JOSEPH M. FARLEY NUCLEAR PLANT, UNIT 1

AMENDMENT TO FACILITY OPERATING LICENSE

Amendment No. 92
License No. NPF-2

ATTACHMENT TO LICENSE AMENDMENT NO. 92

Figure 2.1-1 Reactor Core Safety Limits
Three Loops in Operation

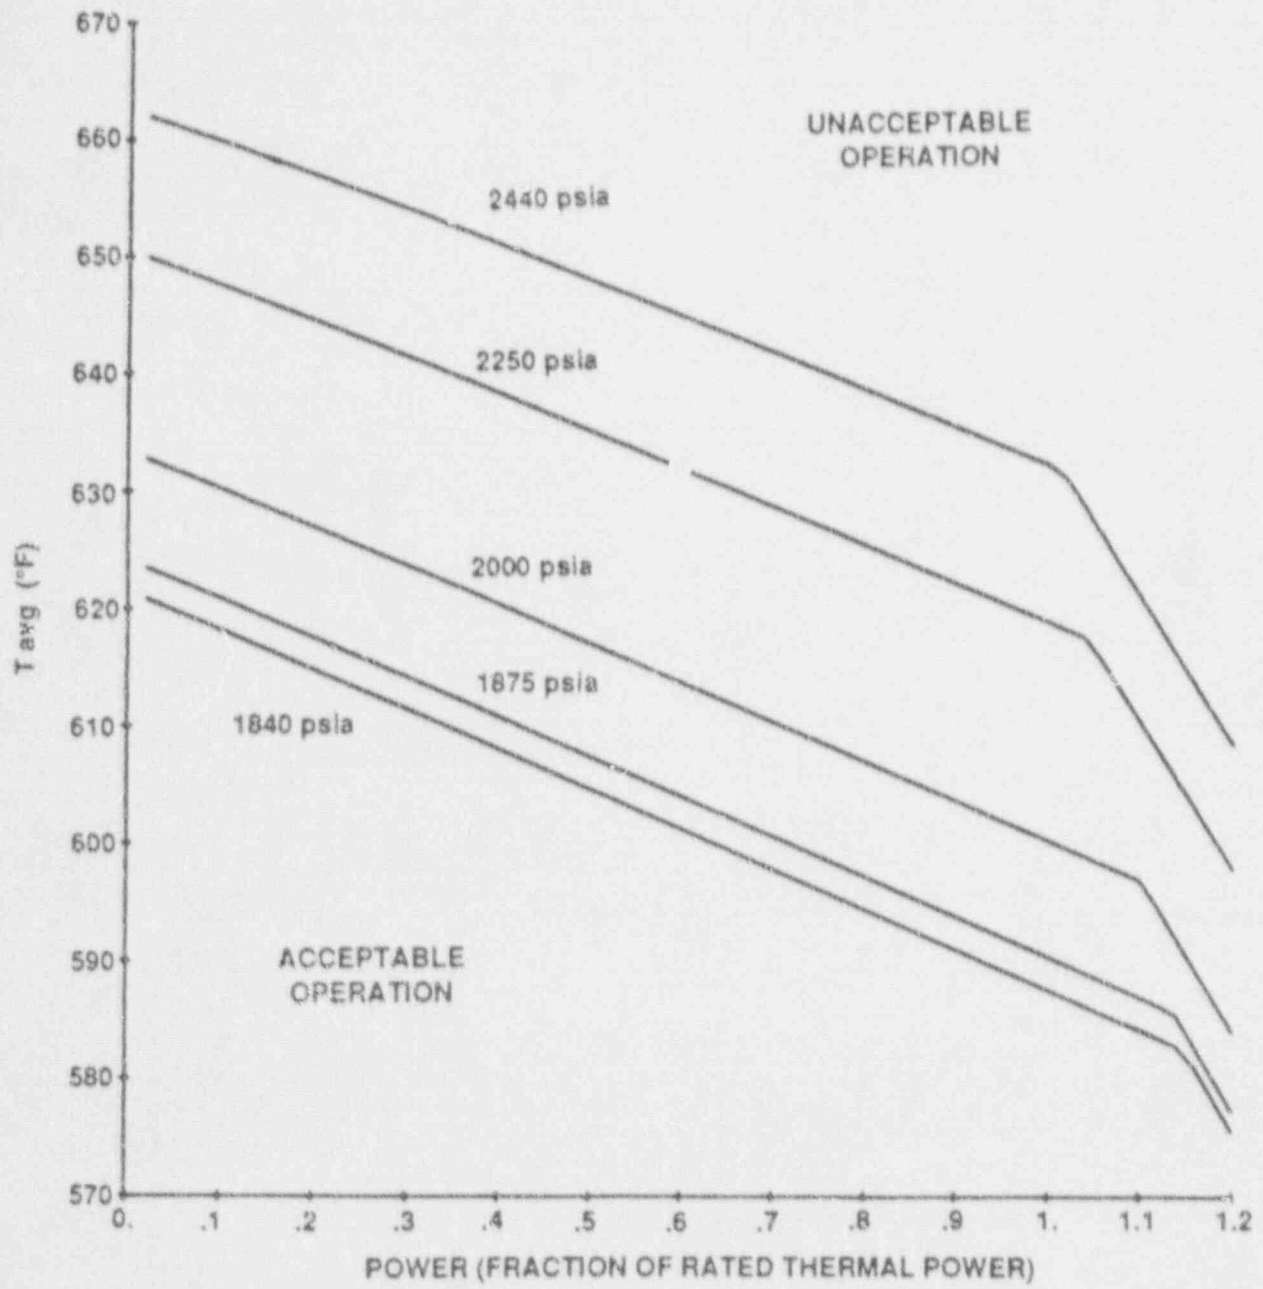
The curves of Figures 2.1-1 and 2.1-2 show the reactor core safety limits for a range of THERMAL POWER, Reactor Coolant System pressure and average temperature which satisfy the following criteria:

The curves of Figures 2.1-1 and 2.1-2 are based on the most limiting result using an enthalpy hot channel factor, $F_{\Delta H}^N$, of 1.65 for VANTAGE 5 fuel and an $F_{\Delta H}^N$ of 1.55 for LOPAR fuel and a reference cosine with a peak of 1.55 for axial power shape. An allowance is included for an increase in $F_{\Delta H}^N$ at reduced power based on the expression:

Figure 3.2-2 $K(Z)$ Normalized $F_Q(Z)$ as a Function of Core Height

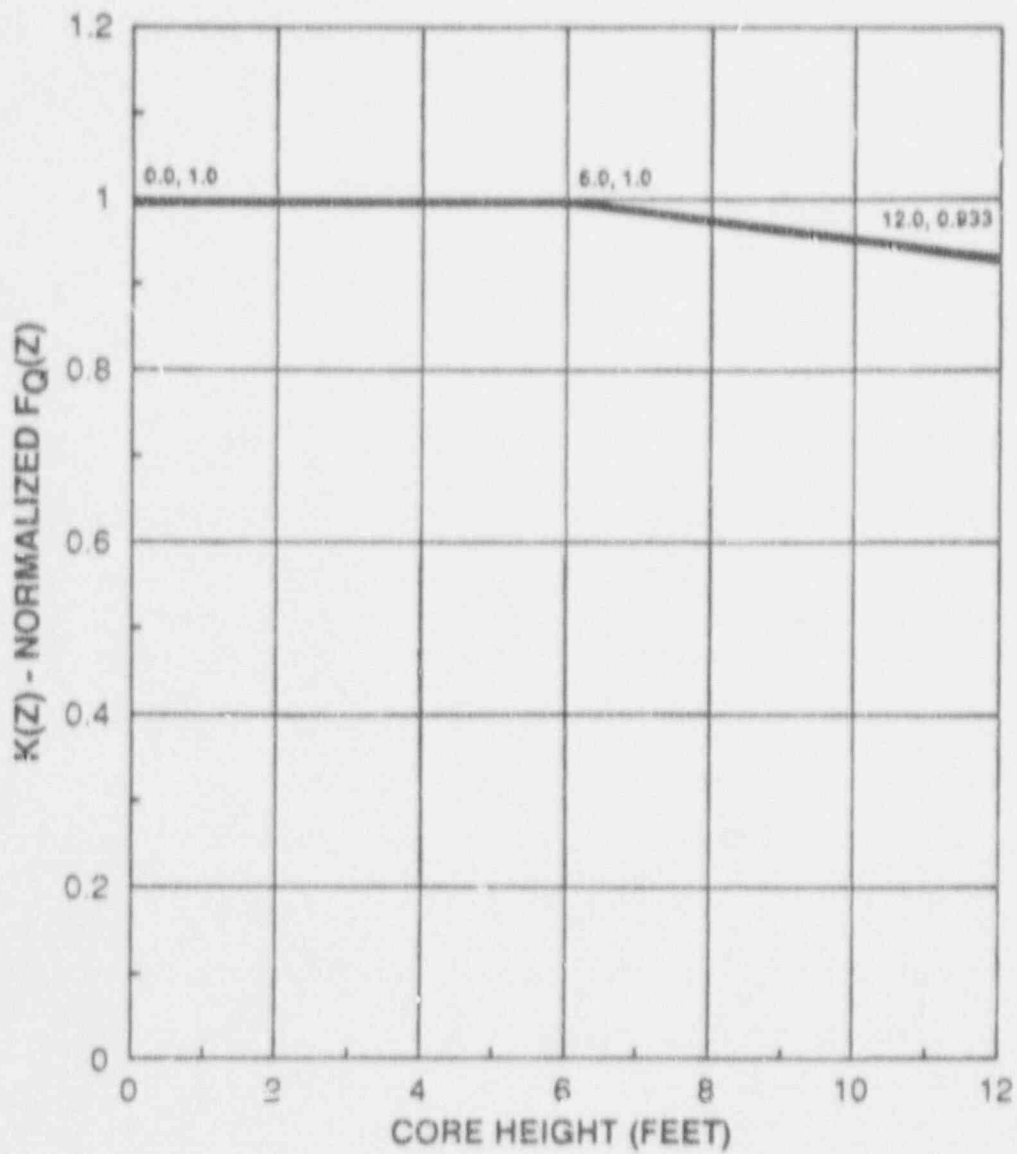
and $K(Z)$ is the function obtained from Figure (3.2-2) for a given core height location.

Figure 2.1-1 Reactor Core Safety Limits
Three Loops in Operation

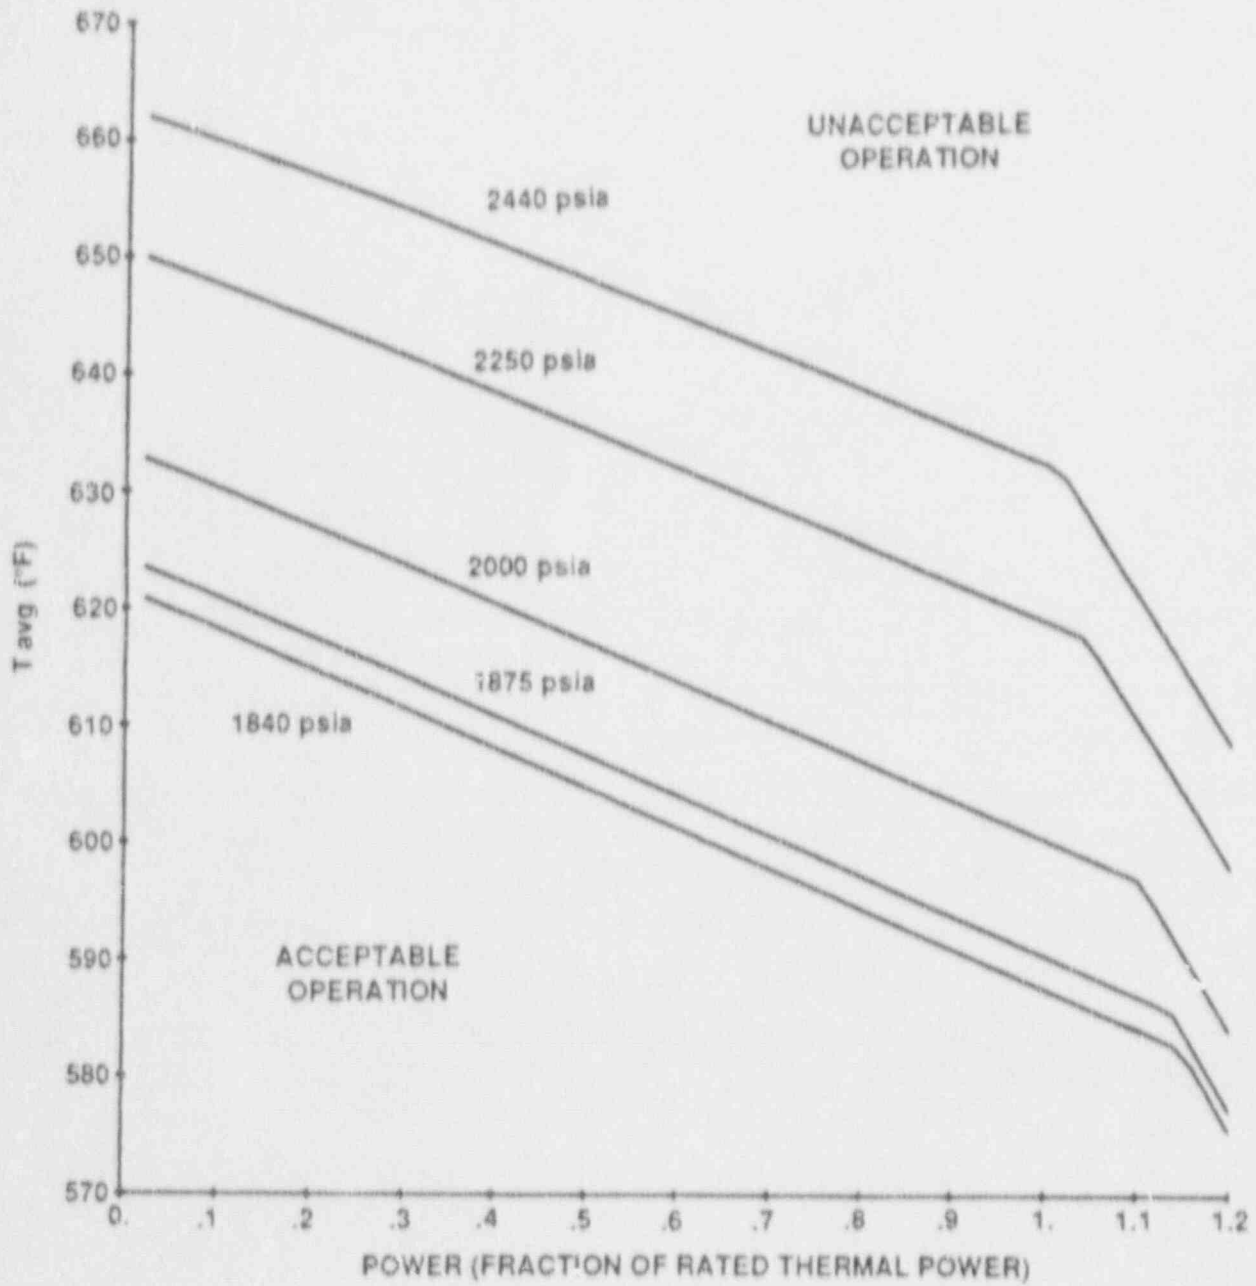
The curves of Figures 2.1-1 and 2.1-2 show the reactor core safety limits for a range of THERMAL POWER, Reactor Coolant System pressure and average temperature which satisfy the following criteria:

Figure 3.2.2 $K(Z)$ Normalized $F_Q(Z)$ as a Function of Core Height

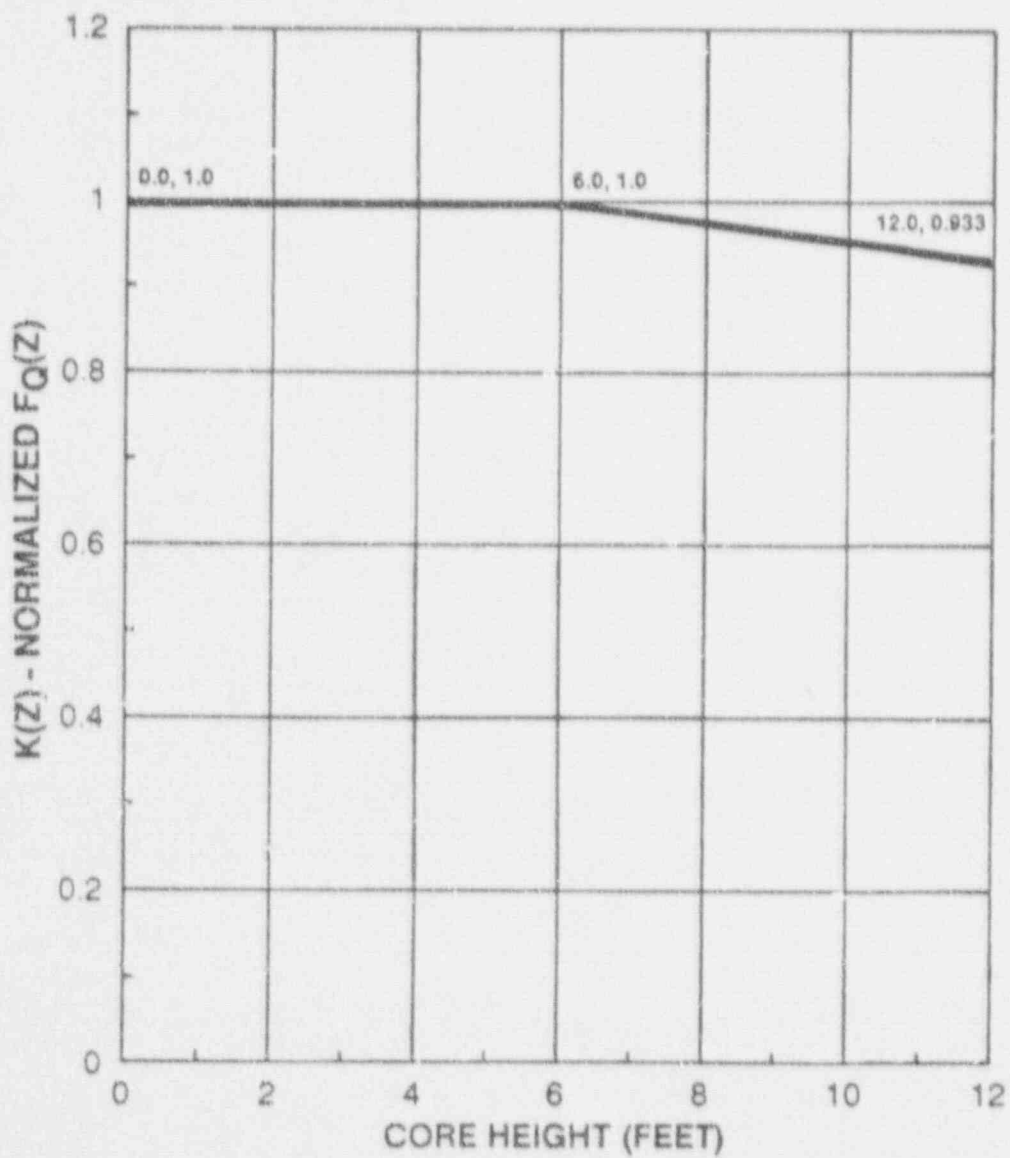
and $K(Z)$ is the function obtained from Figure (3.2-2) for a given core height location.
